Schmidt Parcel – District Infrastructure

FINAL DRAINAGE REPORT

PCD File No. CDR2413

December 2024

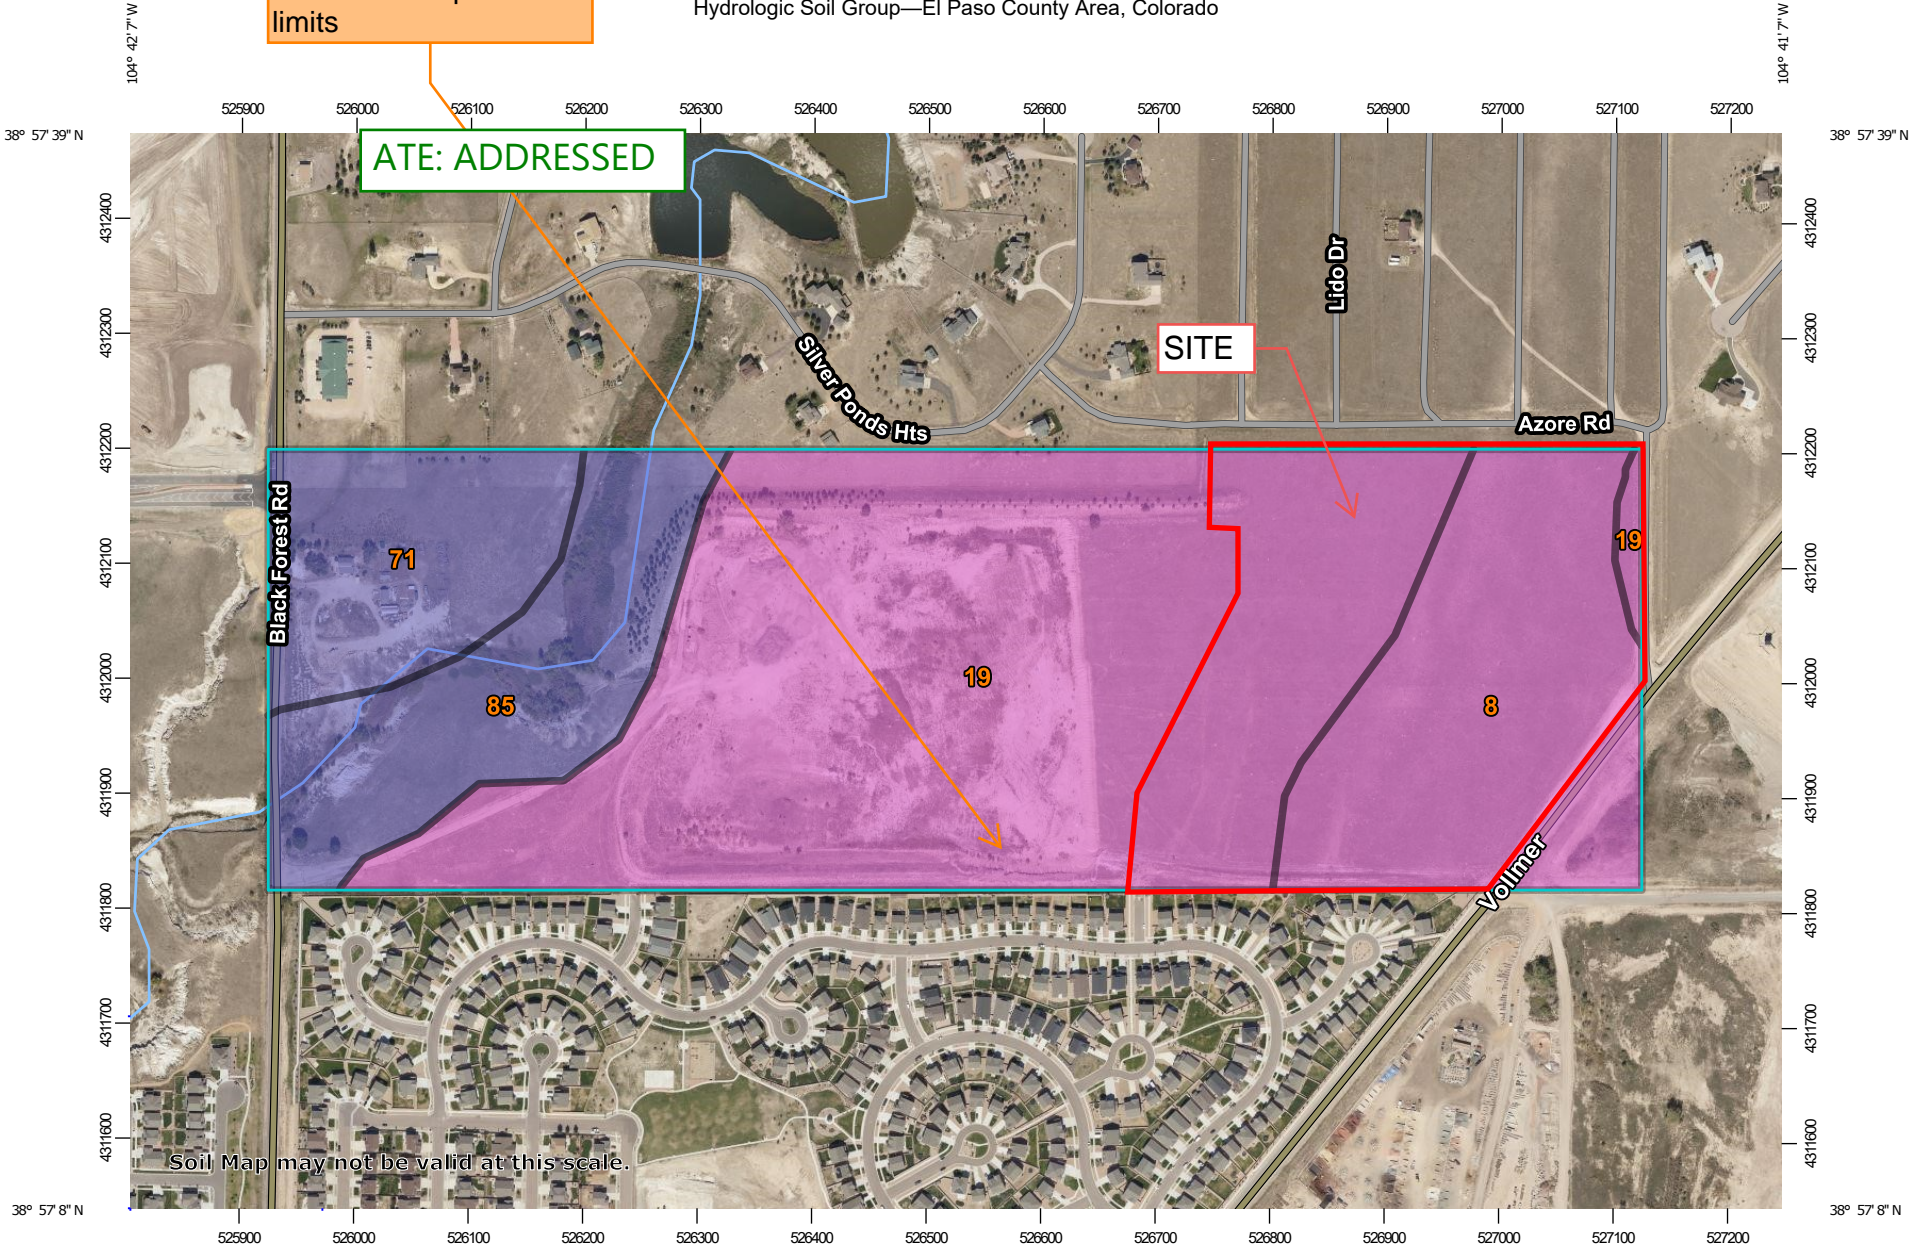
The proposed channel work extends past these limits

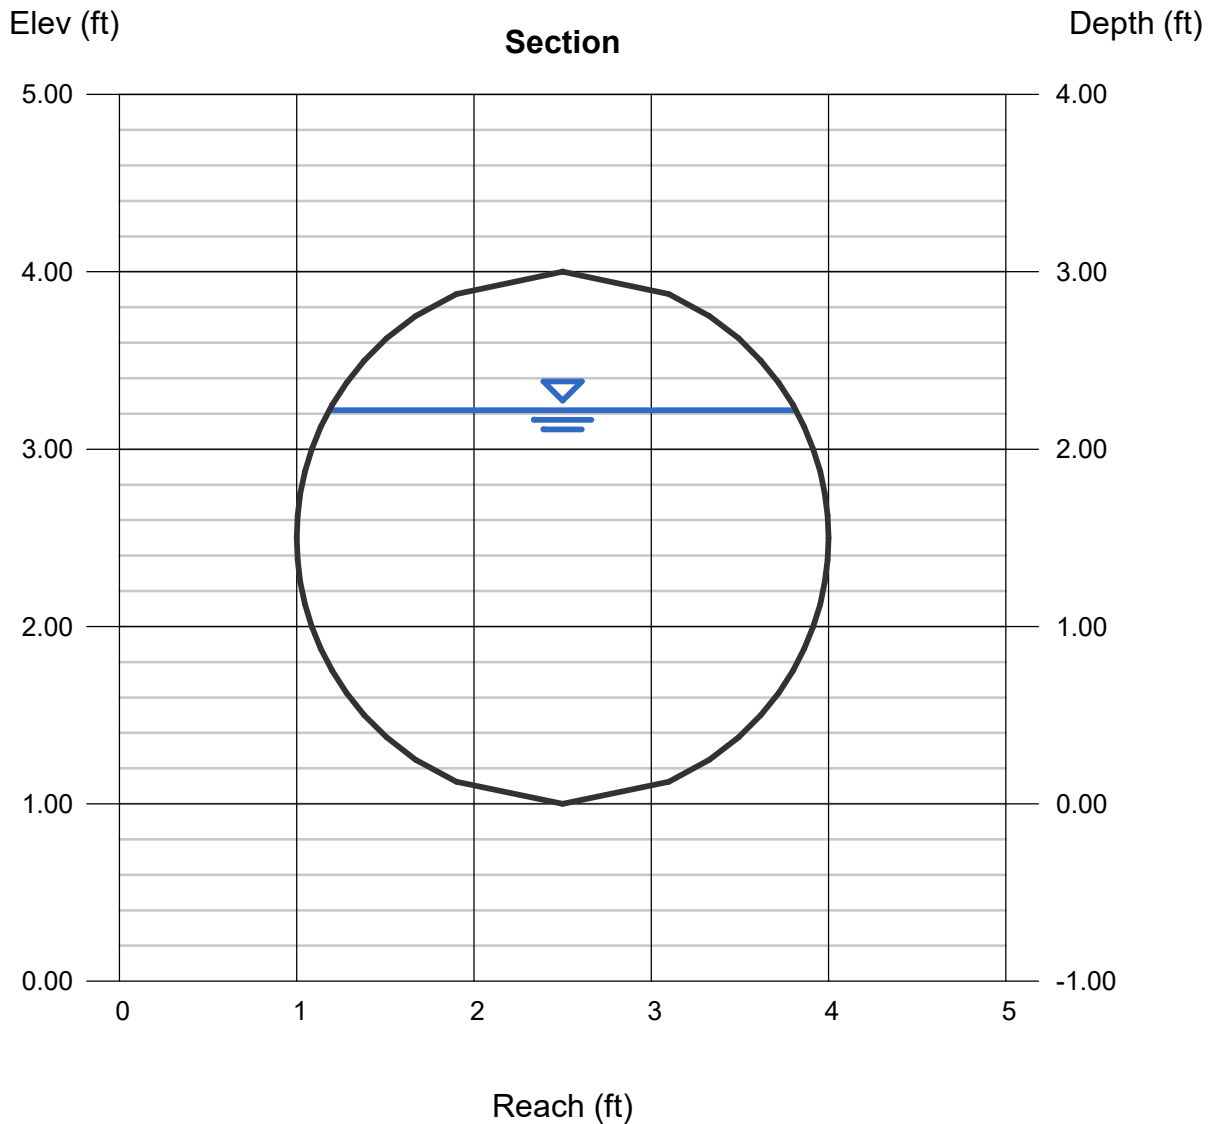
Please put pond component hydraulic analyses in the next appendix with the rest of the pond calcs. Typical comment.

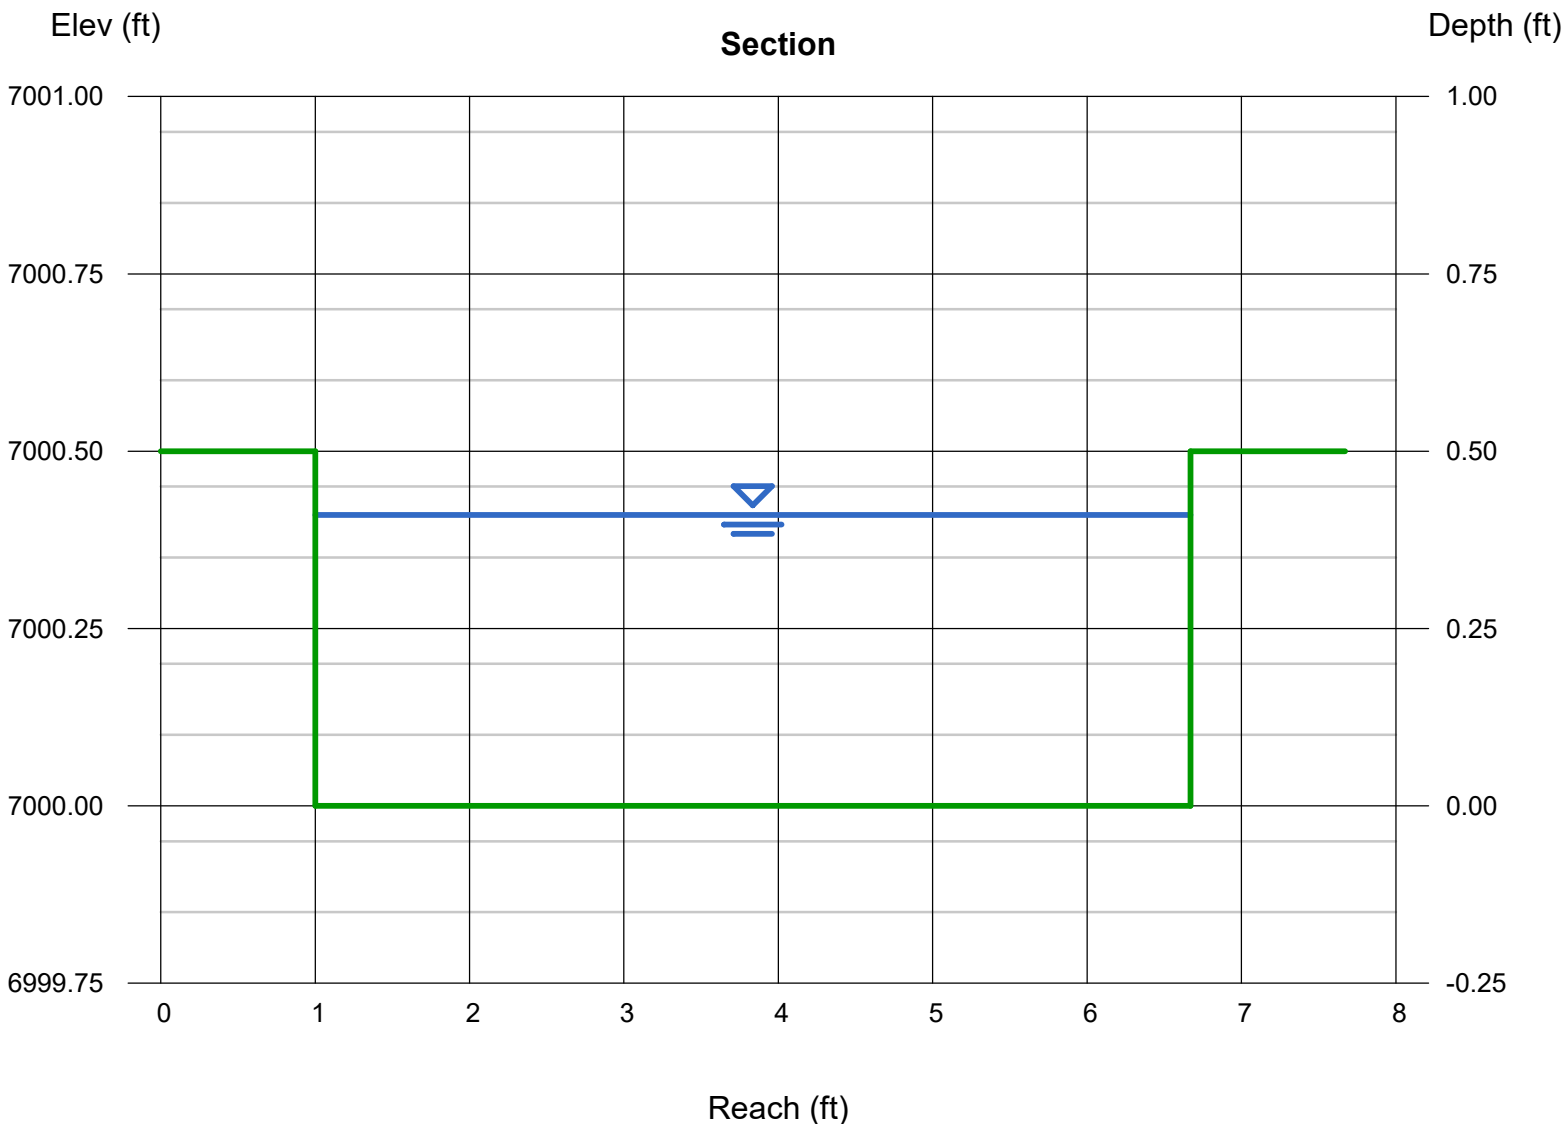
CDs detail this as 6' bottom width. Please adjust to match

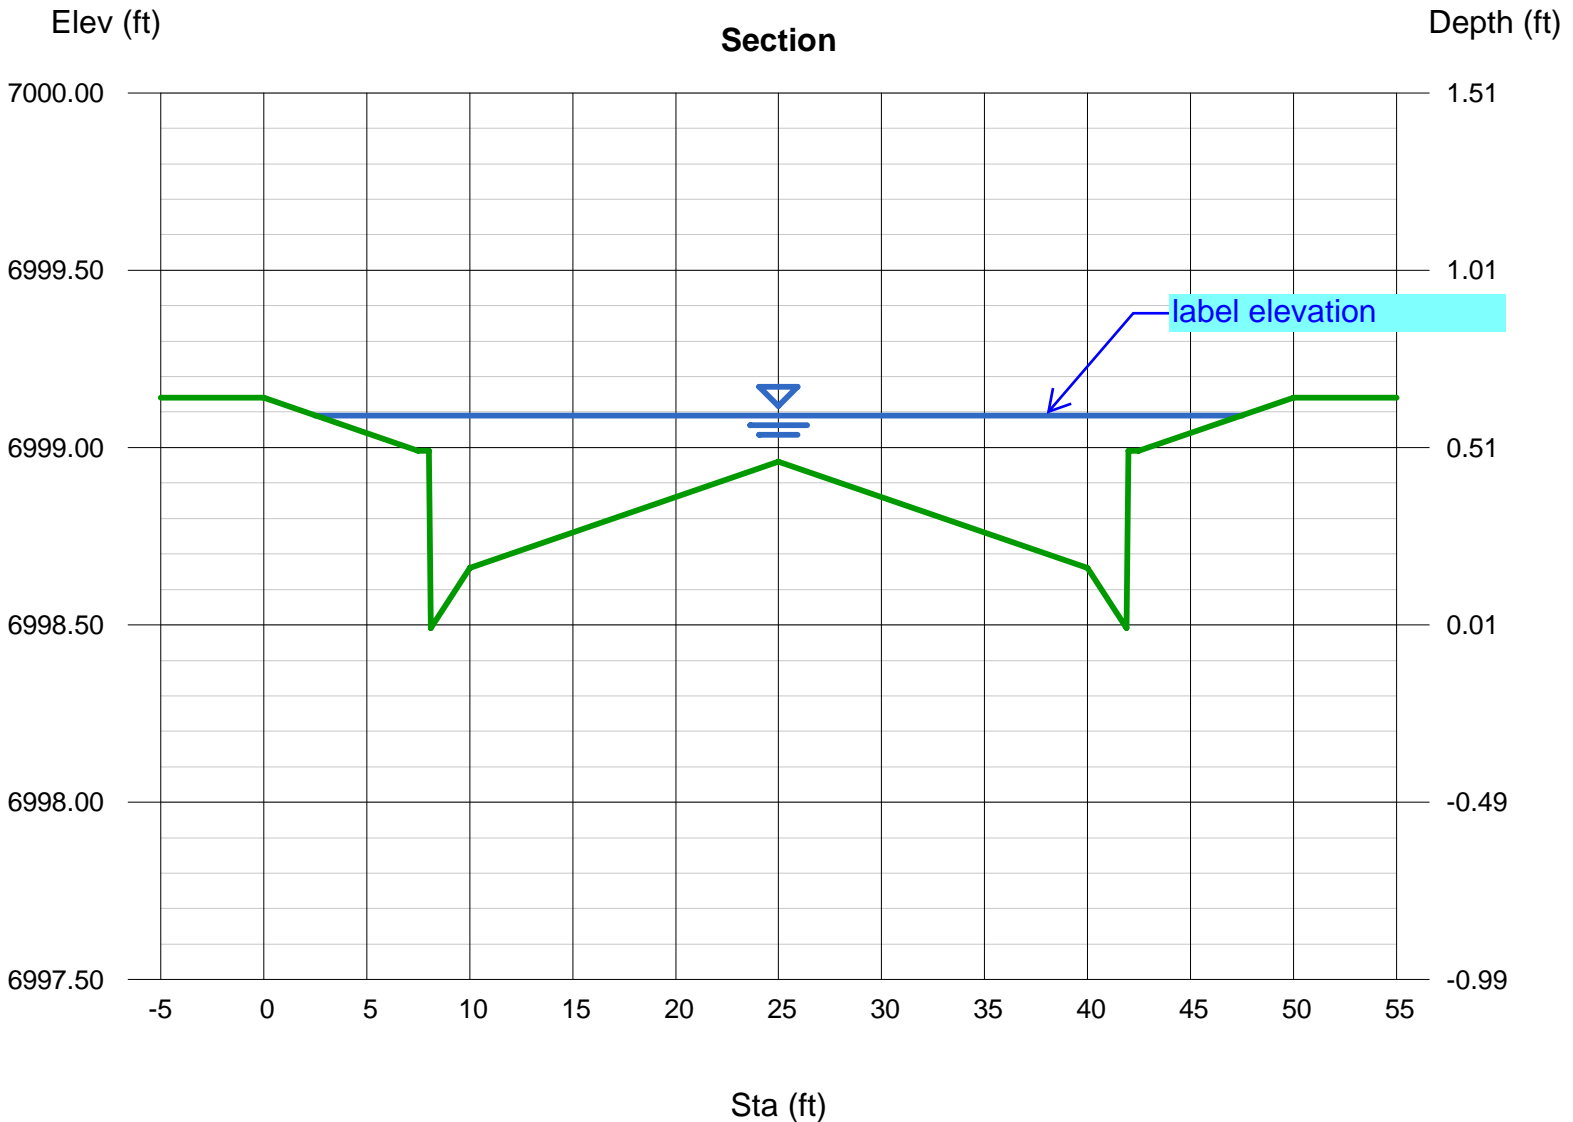
Include roadway classification for added clarity

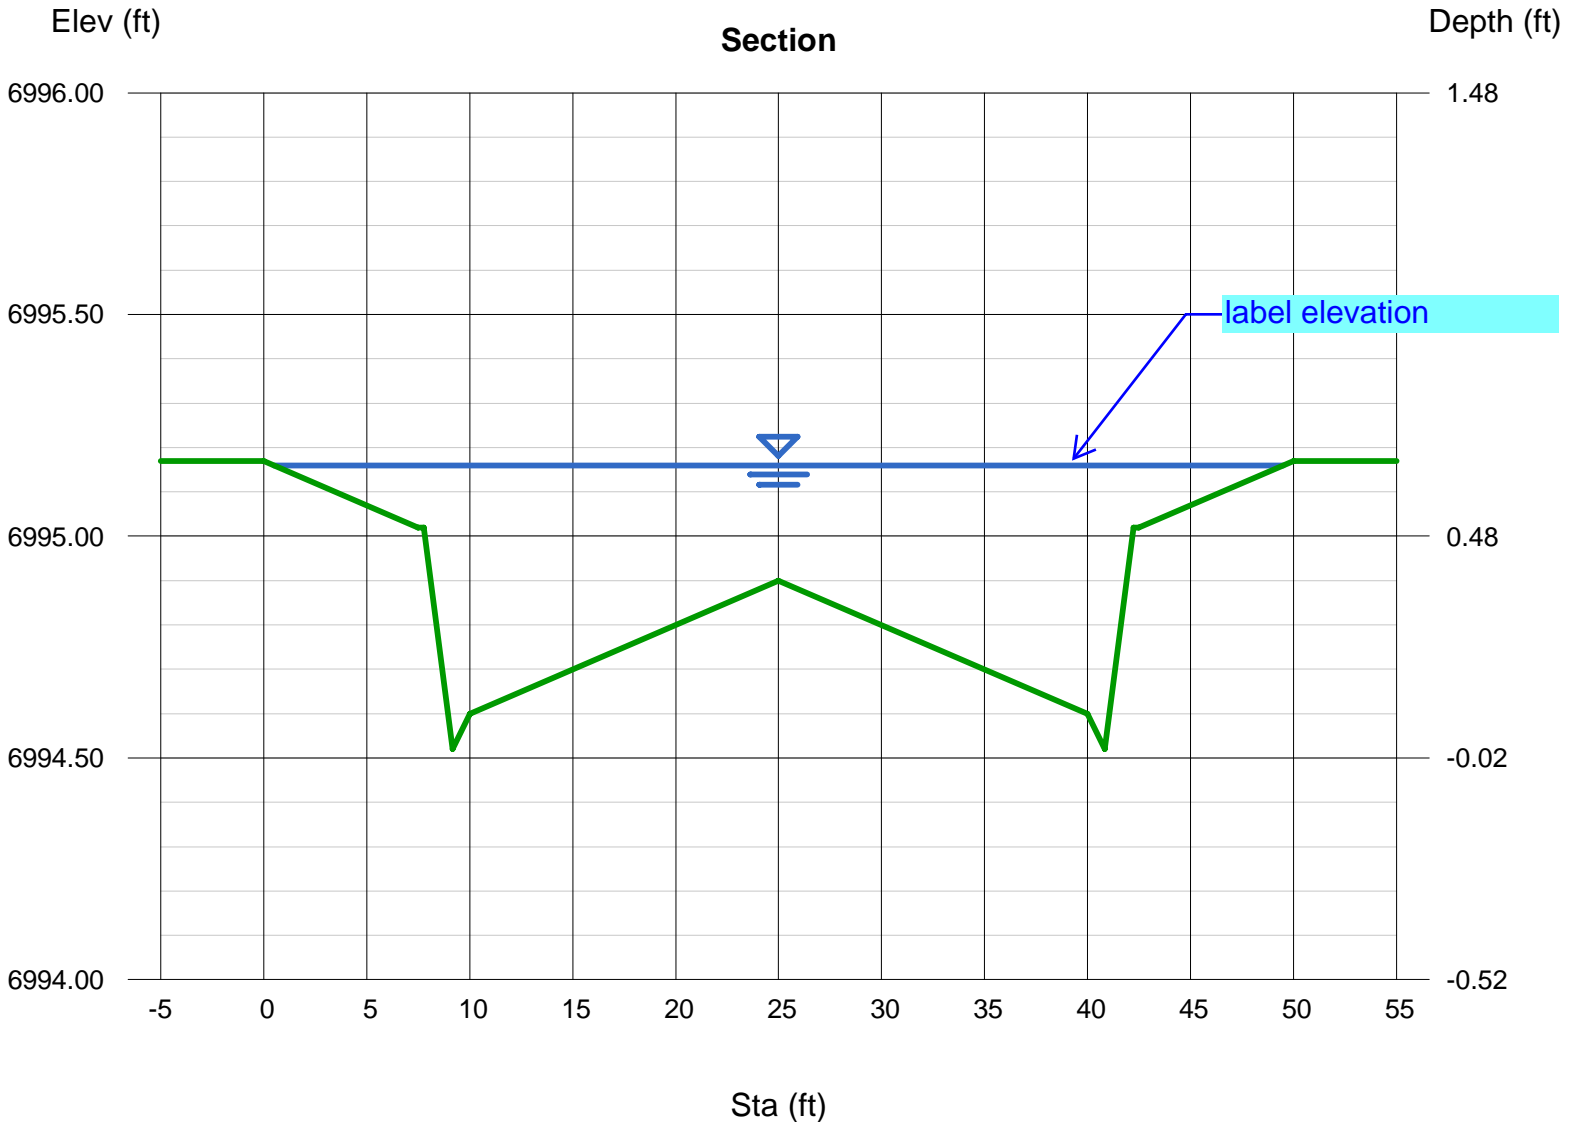
Include roadway classification for added clarity
